Re: Addendum to Preliminary Environmental
Noise Report dated December 14, 2022
Proposed Residential Development
1840 to 1850 Bloor Street
City of Mississauga
Our File: 19-135

As requested by the City of Mississauga Staff, Jade Acoustics Inc. (Jade) has prepared this Addendum to the Preliminary Environmental Noise Report (PENR) dated December 14, 2022, prepared for the above noted proposed development, to address technical review comments from the City of Mississauga.

Re: Response to City Review Comments
Proposed Residential Development
1840-1850 Bloor Street
City of Mississauga
Our File: 19-135

**NOISE CLASS AREA DELINEATION DRAWING
PLAN 43R-####**

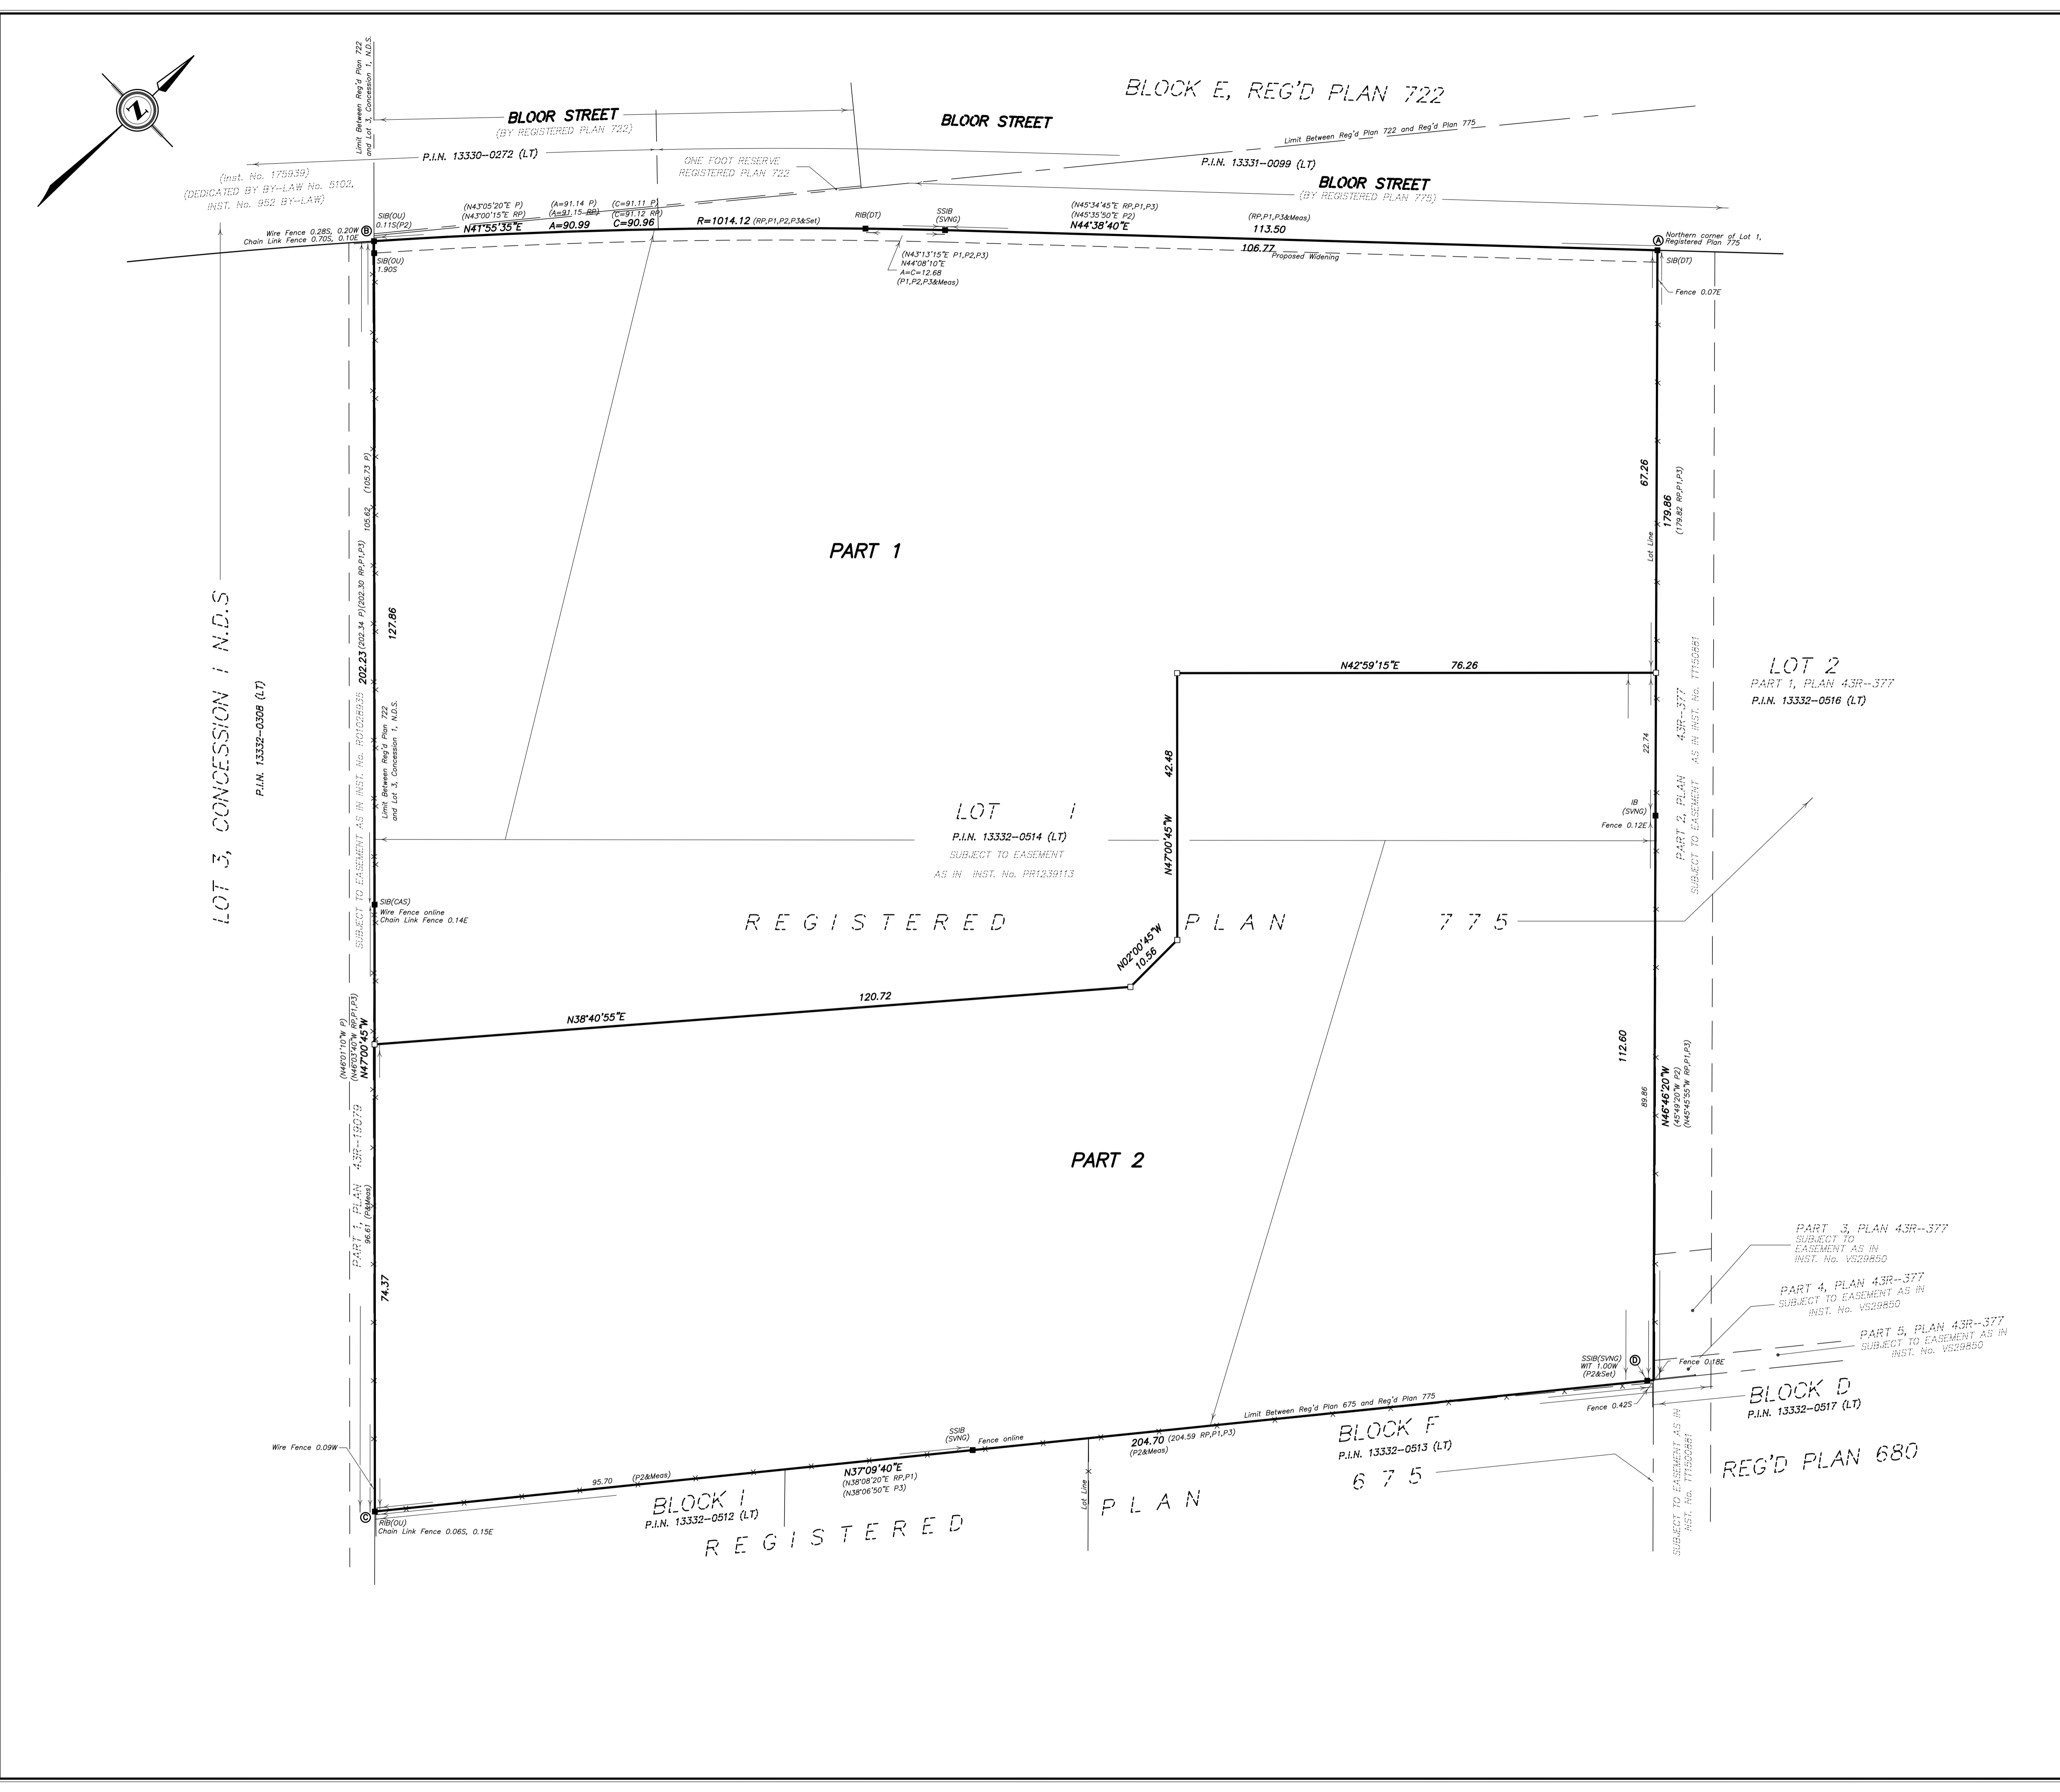
Further to Warning Clause D related to the Class 4 Area designation, implementation of Class 4 was discussed at length with the City, which caused the preparation of an R-Plan (by others) reflecting the Class 1/Class 4 Area delineation through the overall site, owned by the same owner. All Warning Clauses above apply to Part 2 of the R-Plan. The R-Plan has been included herein as Appendix A. Note that the noise class area delineation is also shown in the updated architectural drawings dated June 26, 2024.
